Access Compliance Report Public Rights-of-Way (Curb Ramps)

Main Street: FUTURO_ST		Cross Street: SENDERO_WAY		Location:	NE
ADA ID: RPRK211116140611	Ramp Type: Type 4 - Parallel	Initial Pass/Fail: Fail	Overall Compliance: No	Severity Score:	16

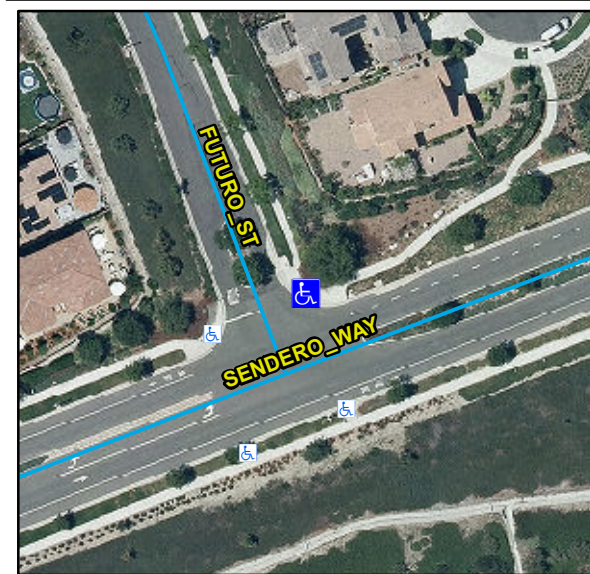
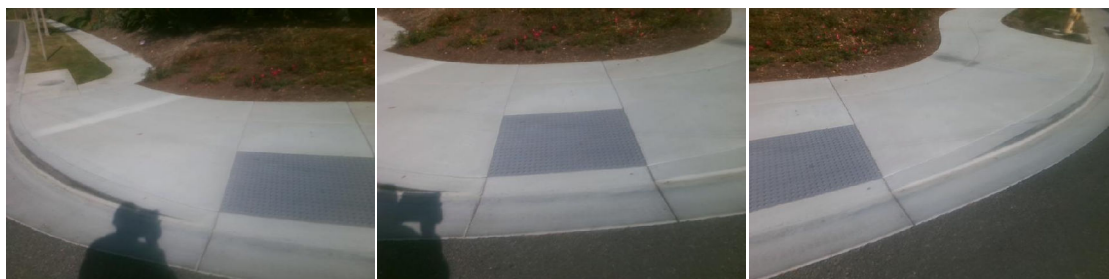
R304.5.3, R304.3.2, STD 1115

Remove & Replace Curb Ramp With Two New Directional Ramps or Equivalent.
